I am writing to let you know that I strongly oppose the unnecessary option to elevate the Waterfront Station and line down Riverside Drive for the following reasons.

MASSIVE HIGHWAY-TYPE BRIDGE WILL BE A BLIGHT ALONG RIVERSIDE DRIVE

Photo of 42' Upper Deck.

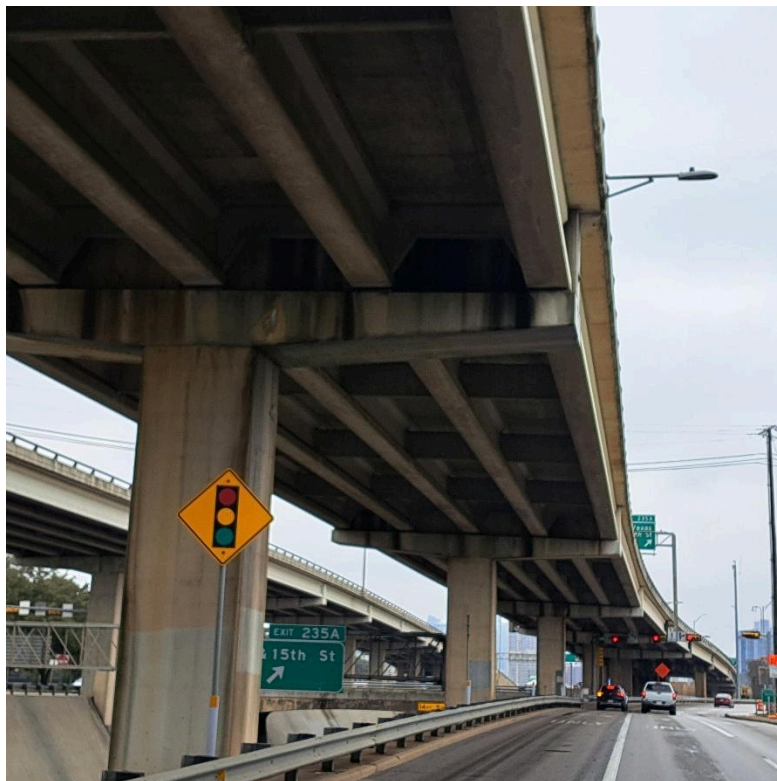
TxDOT REMOVING THE UPPER DECKS OF I35 BECAUSE THEY ARE UGLY AND DIVISIVE

It is ironic that the City and TxDOT are removing the upper decks between MLK and Airport Drive because they are ominous, oppressive, and destroy the fabric of the city yet are hoping to build nearly the exact same type of bridge along Riverside Drive.

This is what Riverside Drive will look like for 1/2 mile (from Alta Vista Ave. all the way to the juncture with the SoCo line near Thundercloud Subs).
